A cycle route on Walter Road

Introduction

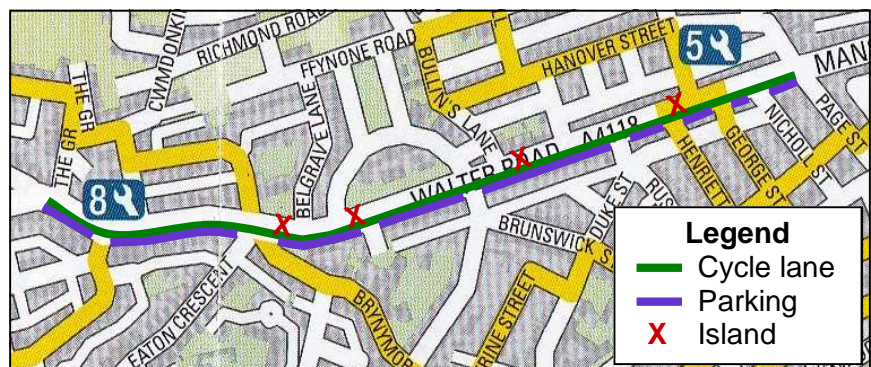
We noted that if parking was provided on the same side as a cycle lane (as shown on the plan above) a buffer between the footway and the cycle lane would be needed to safeguard cyclists from 'dooring'. (A buffer is shown on the Council drawing for the single lane option.)

We noted that the traffic islands (X's on the plan) would interrupt the cycle lane(s), continuity of which we felt important. We thought that replacement of these by single stage crossings would allow both continuity and the free movement of traffic.

- A single one way cycle lane should be provided on the uphill (south) side.
- Parking should be restricted to this side.
- The cycle lane should be at least 2m wide.
